# RECALL BULLETIN 05V-261 (Rev. A)

DATE: OCTOBER 7, 2005  
 MODEL YEAR: 2002– Certain Early Production 2005 Model Years  
 CHASSIS MODEL: UD1200/UD 1300/UD1400  
 BULLETIN NUMBER: SC-261  
FILE IN THE ELECTRICAL SECTION OF THE TECHNICAL BULLETIN BINDER  
 (Discard previous Recall Bulletin dated September 12, 2005)

**VOLUNTARY SAFETY RECALL CAMPAIGN NUMBER 05V-261:  
 BATTERY CABLE REPLACEMENT**

Figure B1 (2002-2004 MY) Without retaining clamp on Transmission mount, use a Tie Strap PN 01552-00043

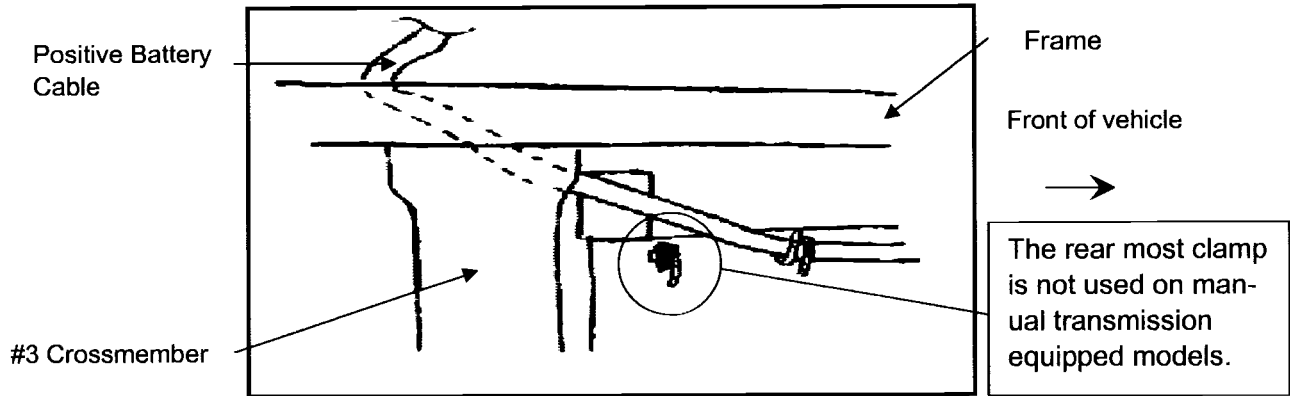
**Step 3A** (Metal retaining ring missing or broken)  
Install, route and secure the battery cable to the chassis harness as shown in Figure B1 using a tie strap PN 01552-00043.

**STEP 3B** (Metal retaining clip in place)  
Install, route and secure the battery cable through the welded metal retaining clamp as shown in Figure B2.

Figure E

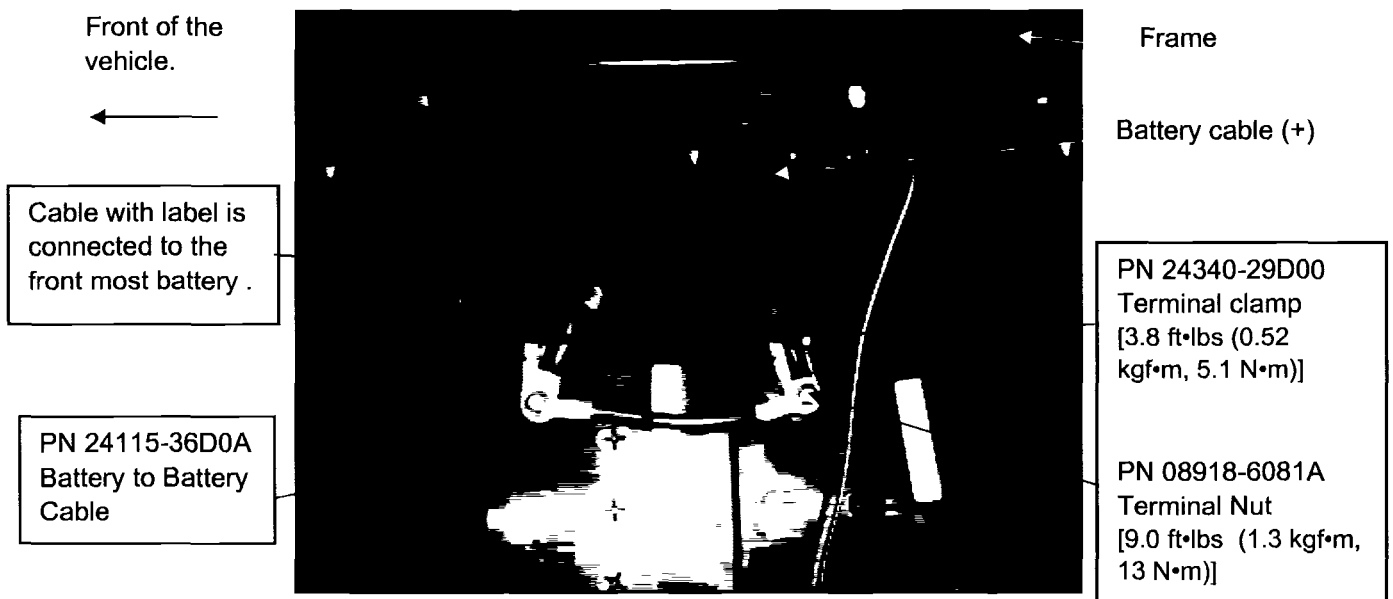
1. Add battery terminal clamp **PN 24340-29D00** to the rear most battery's positive post.
2. Using battery- to-battery cable **PN 24115-36D0A** connect both positive terminals.
3. Attach the alternator feed cable to the rear most battery terminal clamp using nut **PN 08918-6081A** and torque to specifications under References on page 7.
4. Attach the battery cable affixed with a label around the conduit to the front most battery's positive terminal as shown in Figure E.
5. Tighten all connections to the torque specifications under References on page 7.
